No: 25-066

☒ appears to need substantial revision, as indicated.

NOTE: The reviewer has considered this plan a Preliminary and Final Plan as submitted.

PRELIMINARY / FINAL
SITE PLAN
(EXISTING CONDITIONS)
STATE IN
SAVILLE TOWNSHIP
PERRY COUNTY, PENNSYLVANIA

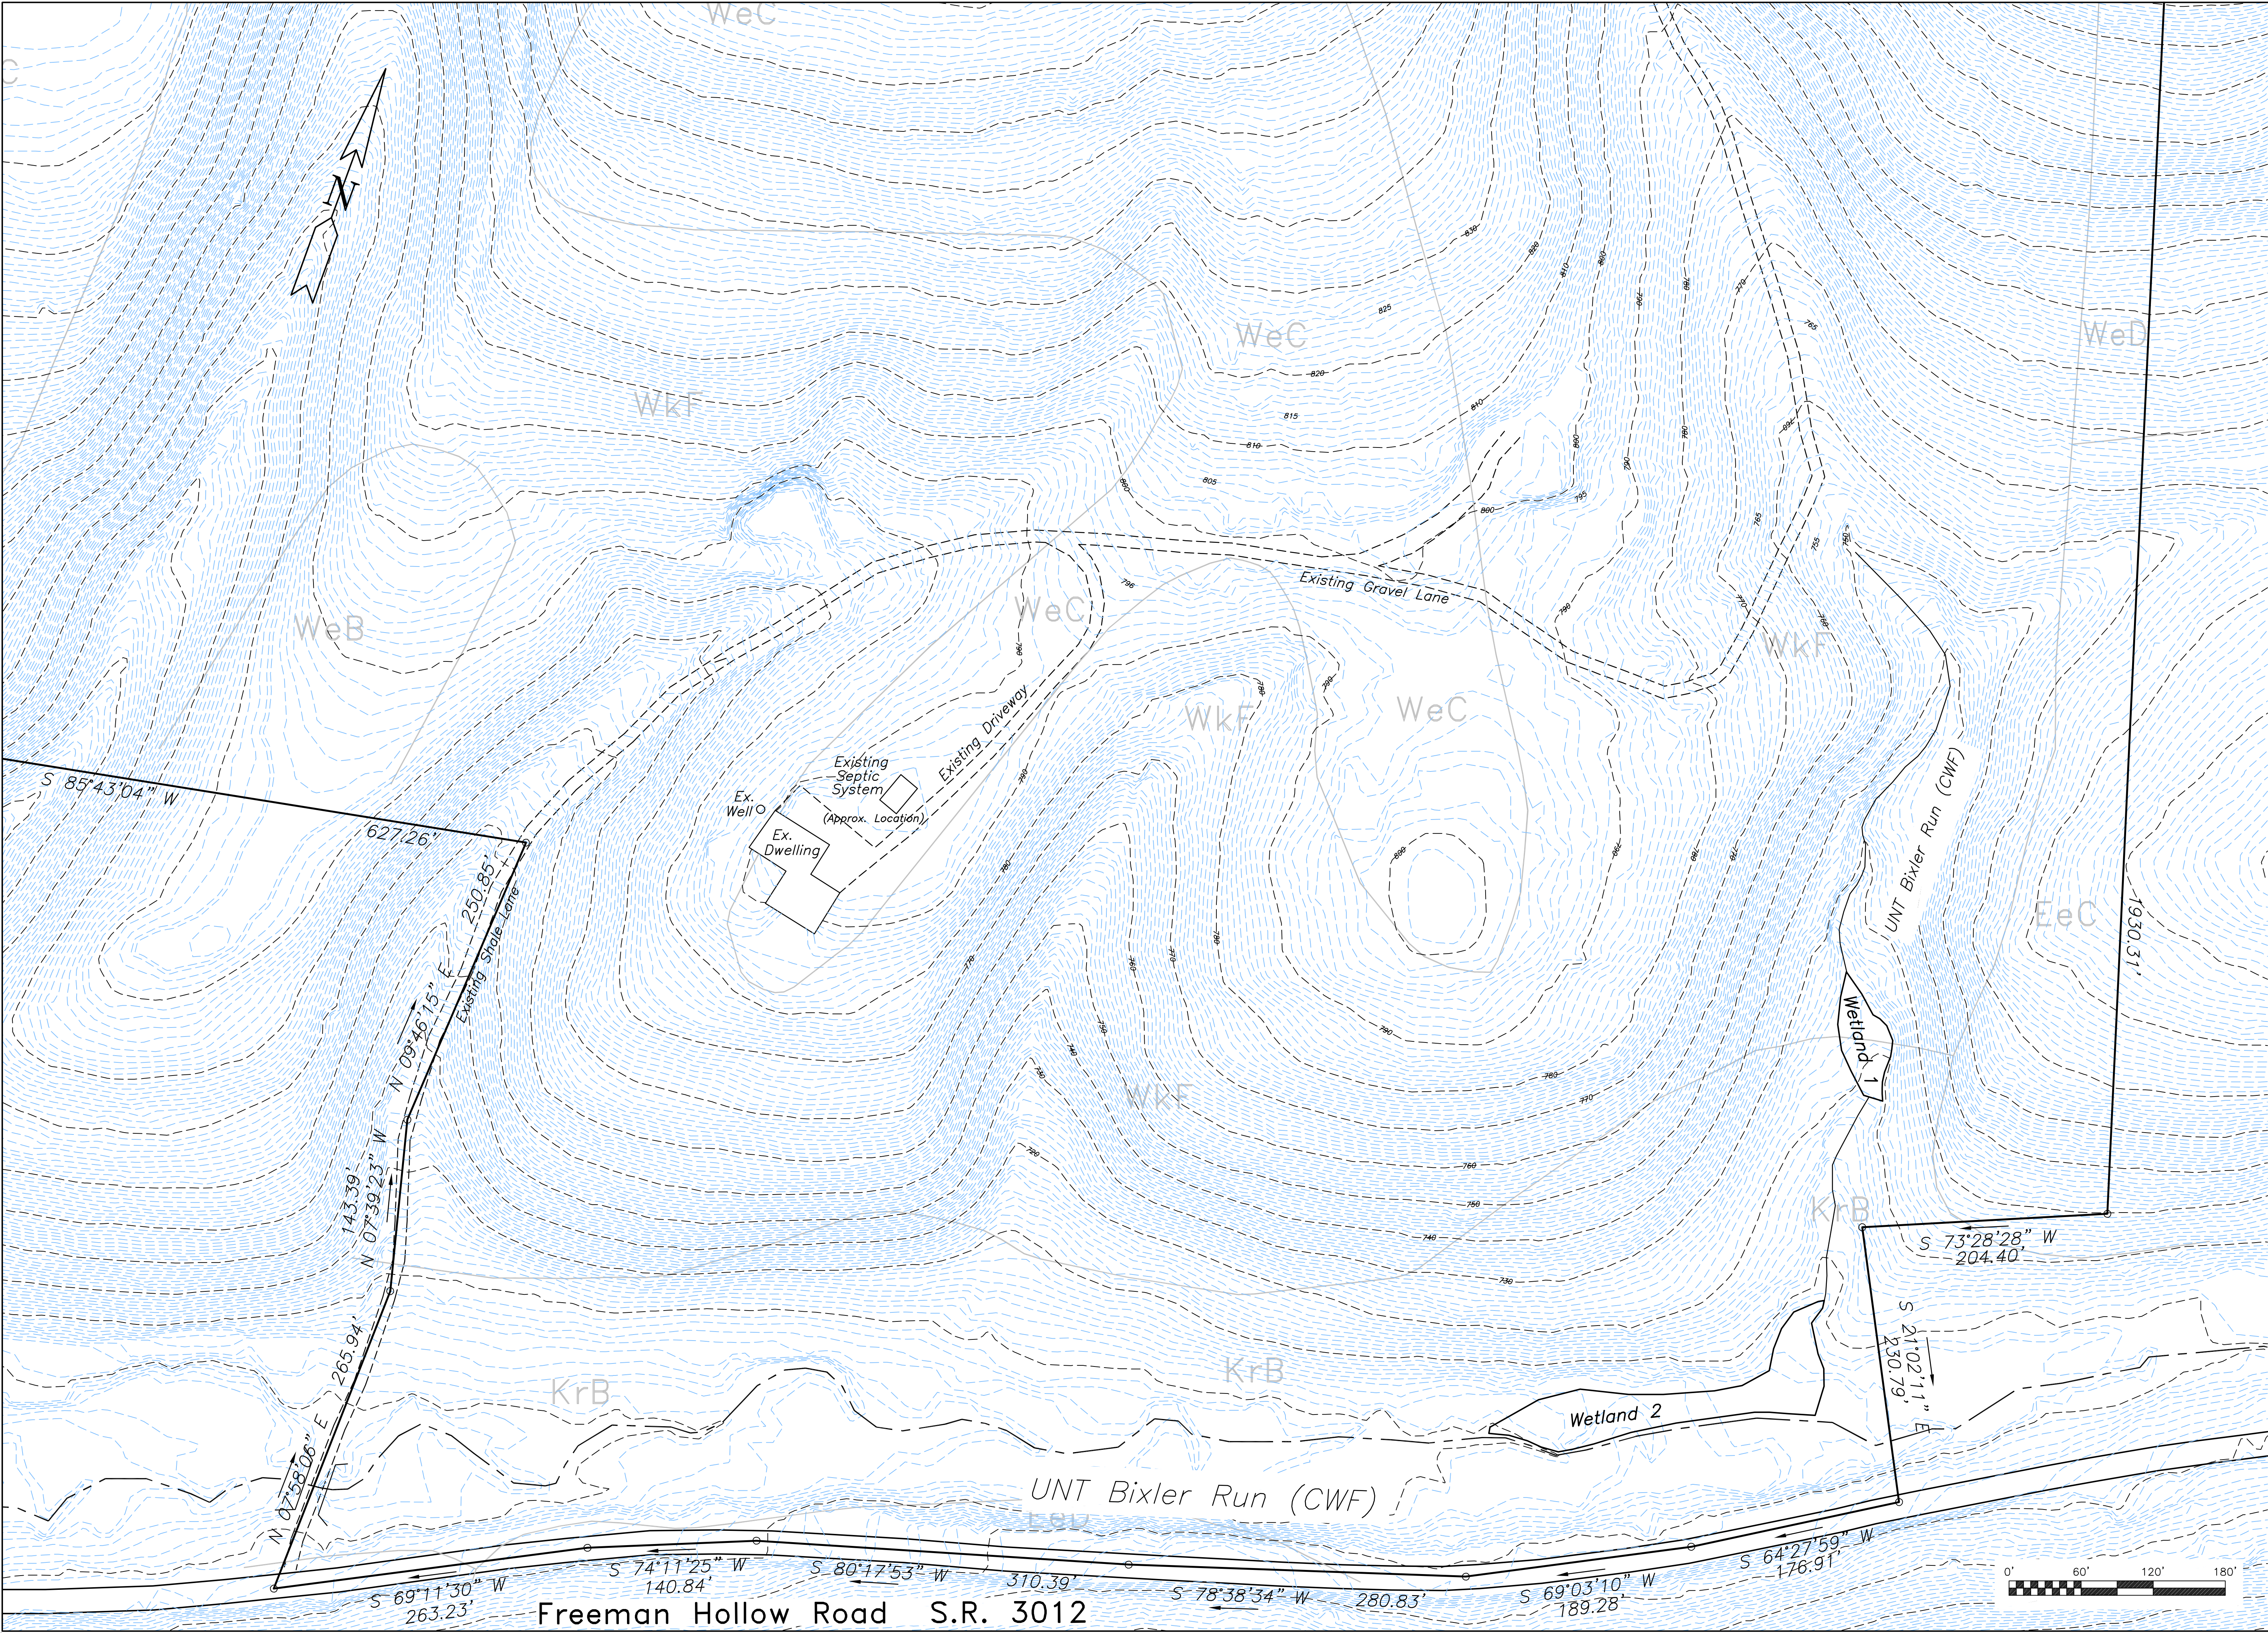
7. Buildings, dwellings, and other structures abutting the lot are required to be shown. (S&LDO § 304.A.1.b.2 per § 304.B.1) Aerial imagery indicates that there are multiple structures on the lot owned by Vernon and Verna Stoltzfus, Michael and Laura Folizzi, and Joan Trostle that are not displayed.

8. Location of existing streets, rights-of-way, and easements is required to be shown (S&LDO § 304.A.1.b.2 per § 304.2.B.1). GIS aerial imagery, and the proposed plat indicate that the existing access road to the existing dwelling is partially located on the property of Michael and Laura Forlizzi. Is there an existing easement or right-of-way? If so, it is required to be displayed.

10. Water courses, bodies of water are required to be displayed. (S&LDO § 304.A.1.b.2 per § 304.2.B.1) A GIS-generated layer from the National Wetlands Inventory indicates a riverine area that is adjacent to the entirety of Bixler Run that is not displayed. Additionally, there is a small, minor stream located in the northwest section of the property that is not displayed.
11. Easements for utilities are required to be displayed. (S&LDO § 304.A.1.b.2 per § 304.2.B.1)
12. The location and identification of all existing permanent survey monuments and the location are required to be displayed. (S&LDO § 304.A.1.b.7 per § 304.B.1)
13. Building setback lines on all lots are required to be displayed. (S&LDO § 304.A.1.b.11 per § 304.B.1)

PRELIMINARY / FINAL
GRADING / E & S PLAN

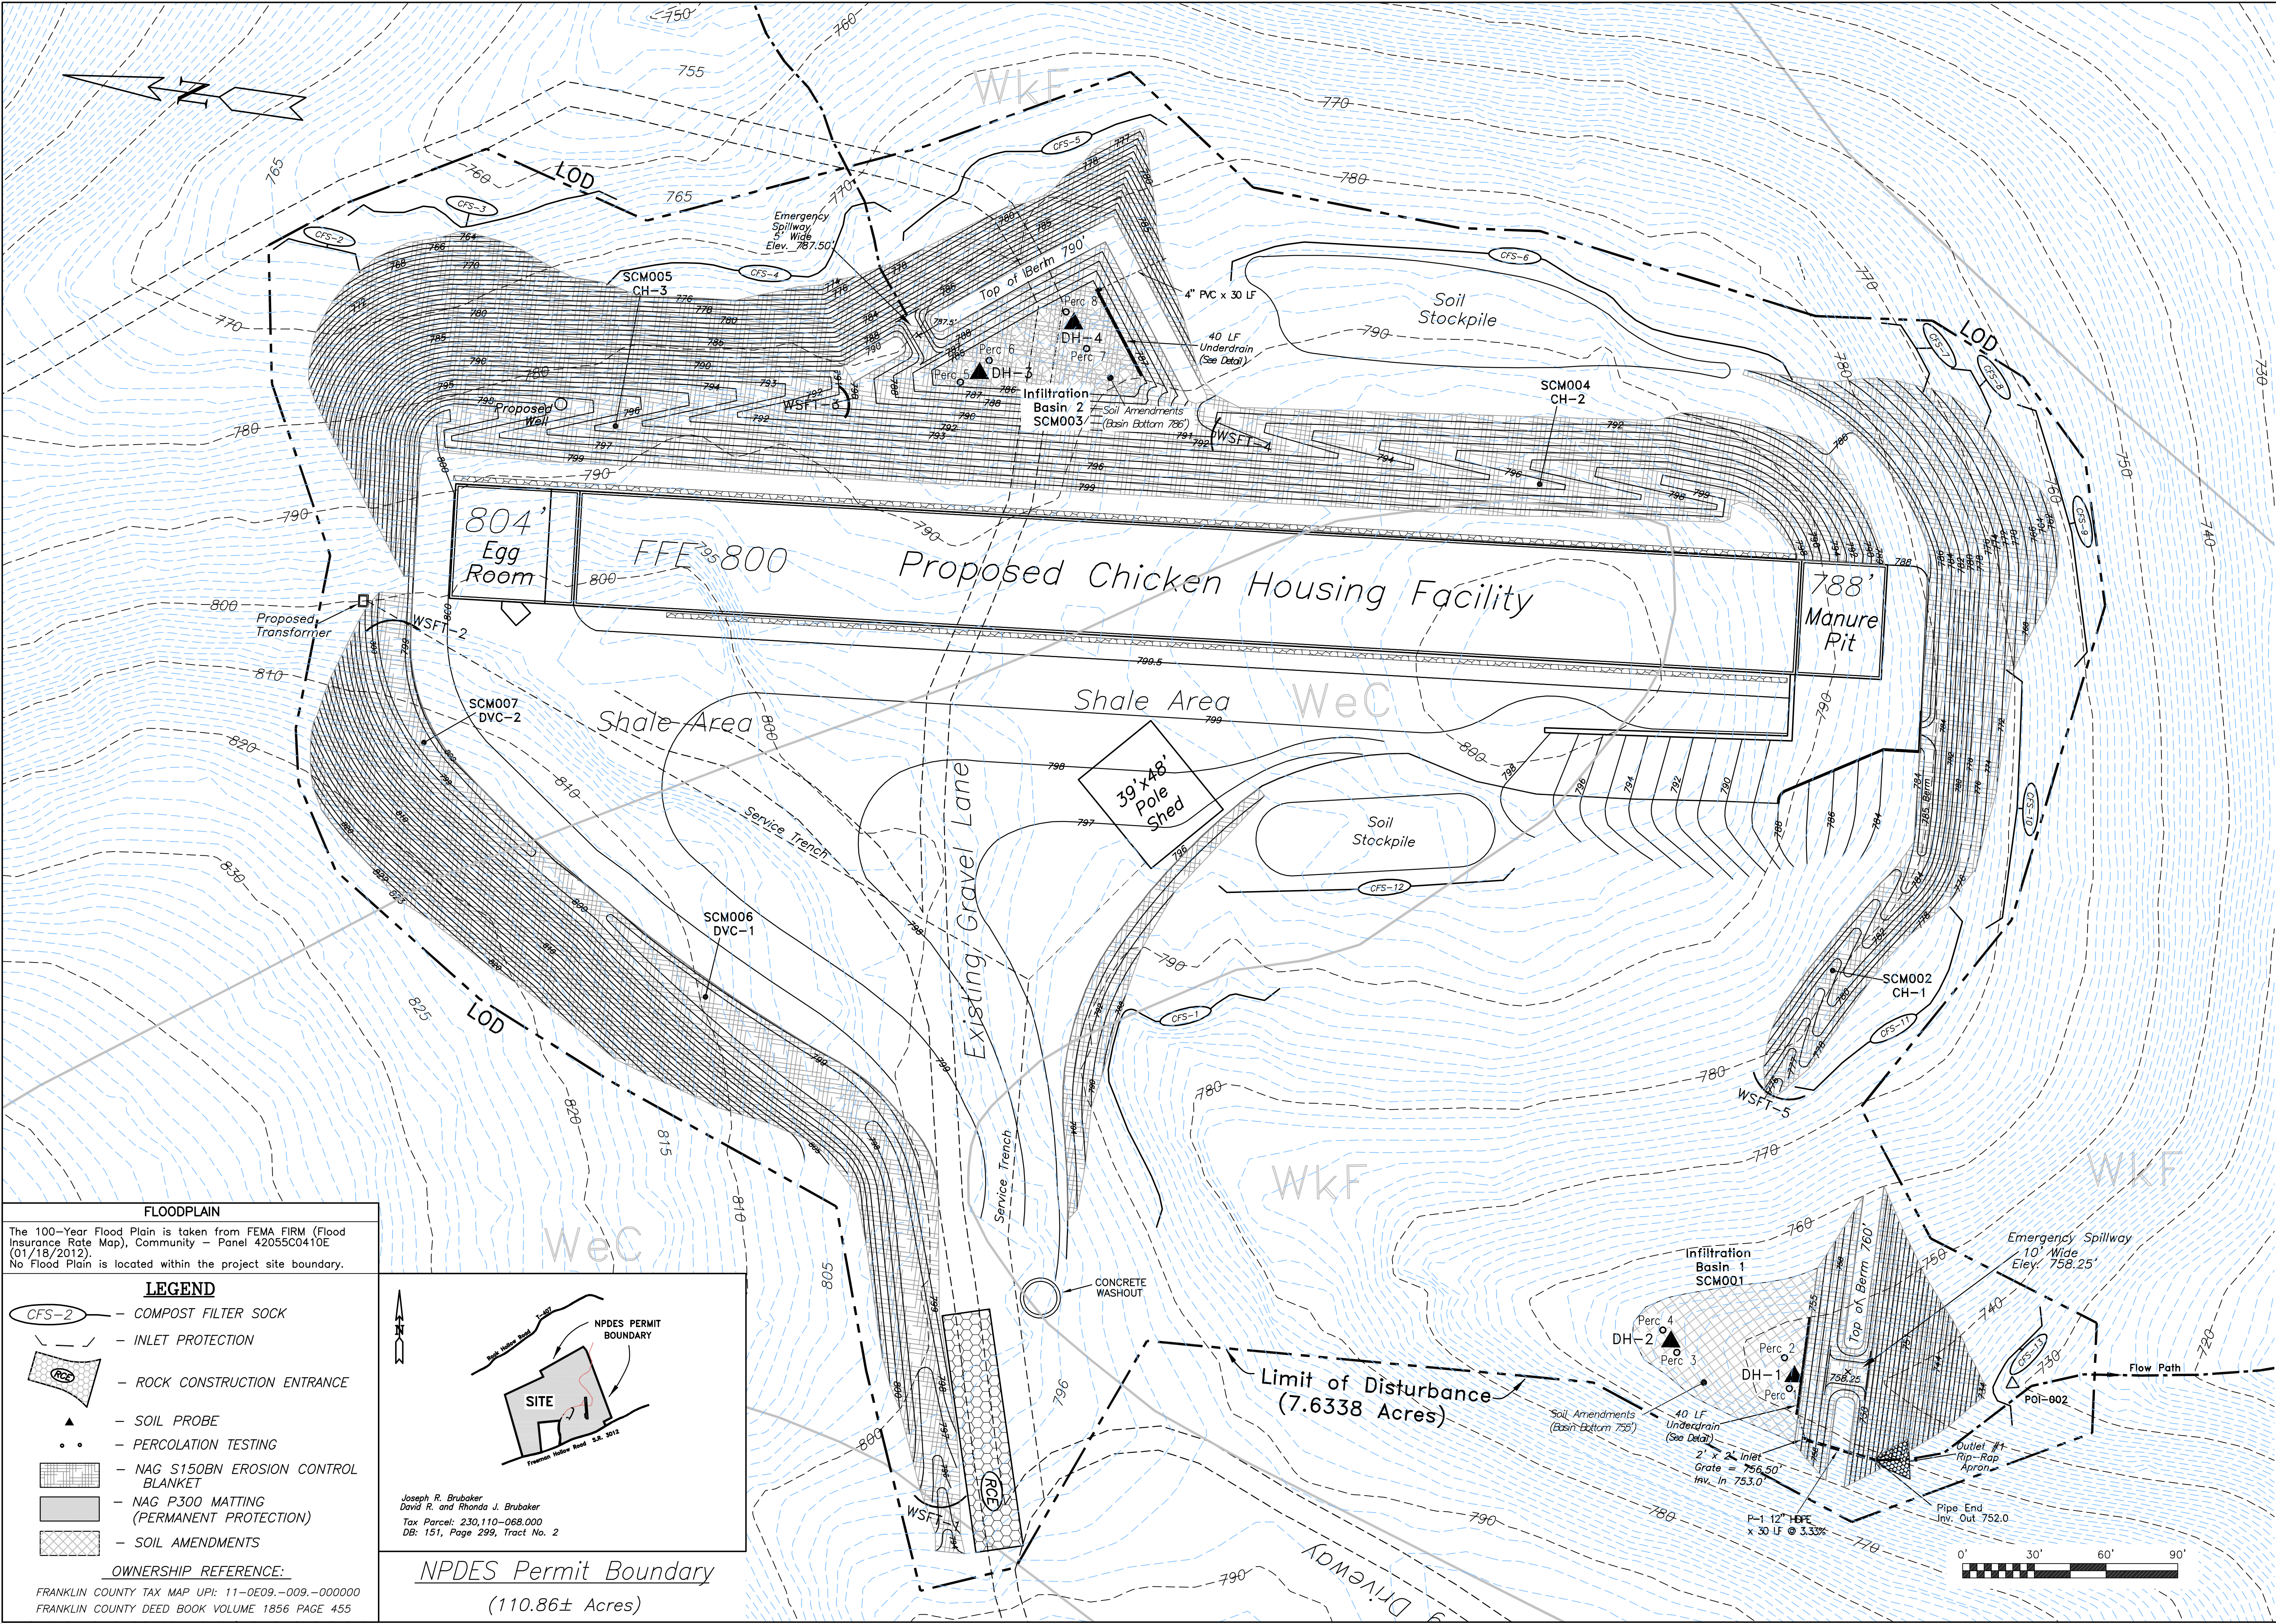
1. With the amount of land disturbance, a NPDES permit will be required for this land development.
2. The existing gravel lane extends well past the proposed chicken housing facility. Where does the gravel lane terminate and is it used by any other landowners for access?

3. The plan displays a gravel lane going through the proposed chicken housing facility and through the proposed infiltration basin #2. Will the gravel lane be removed from extending onto adjoining lands without any rights-of-way reservations or road improvements if needed? If so, any applicable scenario should be noted and explained by the plan.

4. It is noted that the proposed location of the chicken house and area of disturbance appears to be on Hydric soils (WeC).
5. A significant portion of the existing property contains slopes that are 15-25% or greater than 25%. It would be helpful to display slopes on the plan for appropriately situating the location of the proposed chicken house and shale driveway area.
